APPLICATION CONTINUANCE FROM 11/16/17 BHAC HEARING:

BHAC HEARING | 2017.12.21

JOHN JEFFRIES HOTEL

SITE PLAN - 11/16/17 BHAC RECOMMENDATION

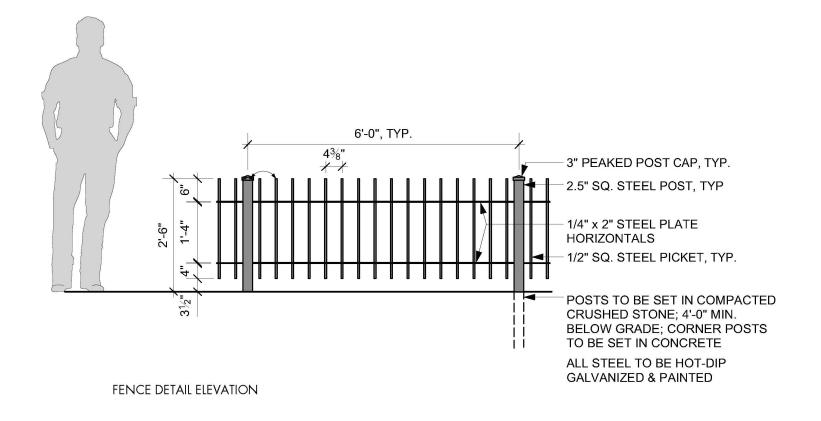
- 1. REDUCE AREA OF GRANITE PAVERS AT THE NORTH ENTRANCE.
- 2. PROVIDE LOWER FENCE ALONG MUGAR WAY SIDEWALK.
- 3. REDUCE SCALE OF EXTERIOR SCONCES.
- 4. PROVIDE ALTERNATE LIGHT FIXTURES IN LOGGIA.

ENTRY PAVERS
